COVER OF SPECIFICATION 规格书

No.: AN03445

Rubber Antenna

G-RA0025179005-SZ478

TITLE	Rubber Antenna	版次	SCALE	1 : 1	DRAWN	陆东	14/03-23
PART NAME	G-RA0025179005-SZ478	D	MATERIAL		INSPECTED	陈发	14/13-23
BONDAL ELECTRONICS LTD.			HANDLING		APPROVED		
			PROJECTION (視角)	☐	☉	SHEET

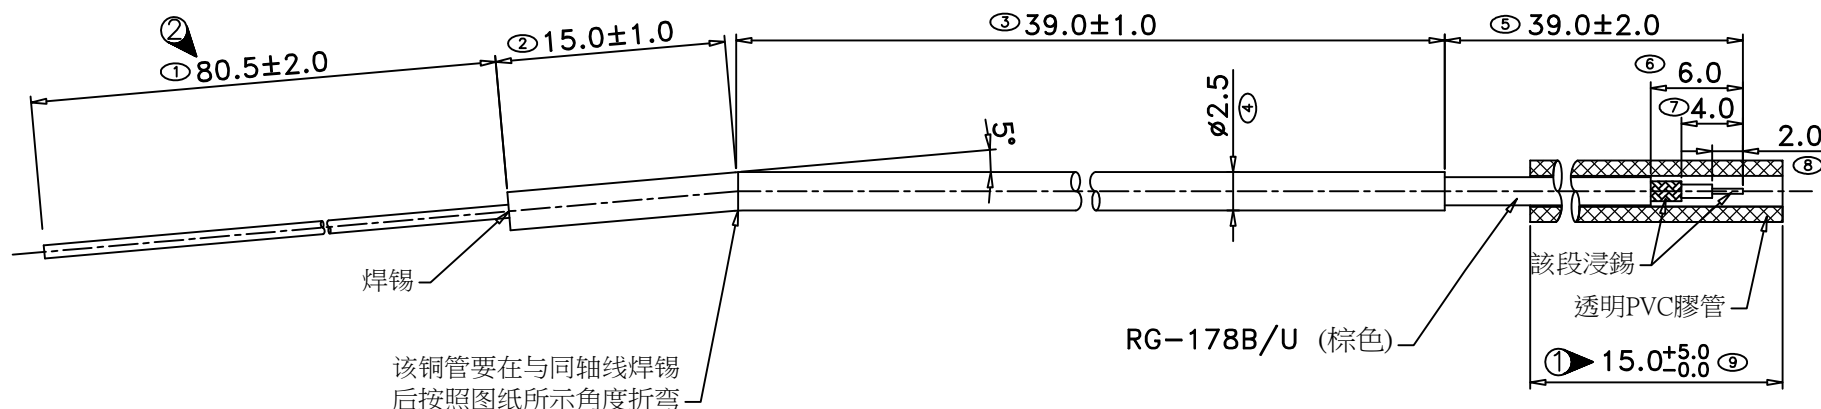
REV.	ISSUE FOR	OLD DRAWING NO.	APPROVED	80<L<=250	±0.50
①	根据实际情况把透明PVC胶管的长度由48.0 ^{+5.0} _{-0.0} 改为15.0 ^{+5.0} _{-0.0} MM.	G-RA0025179005-SZ478(A)	曹新学	25<L<=80	±0.40
②	用客户机壳重新调试频率,芯线长度由 69.0±2.0改为80.5±2.0.	G-RA0025179005-SZ478(B)	陸 東	8<L<=25	±0.30
③	应客户要求,将频率由915±10MHz改为915±15MHz.	G-RA0025179005-SZ478(C)	陸 東	L<=8	±0.20
				線性尺寸L	未注尺寸偏差
				未注明公差

1. 工作頻率為:915±15MHz.
2. 同軸線線芯外露部分套一截透明PVC膠管以保護芯线,長度為15.0^{+5.0}_{-0.0} mm
3. ▲ 為重點管控尺寸.
4. ⊙ 為做FAI尺寸.
5. 客户PARTNO:E02520
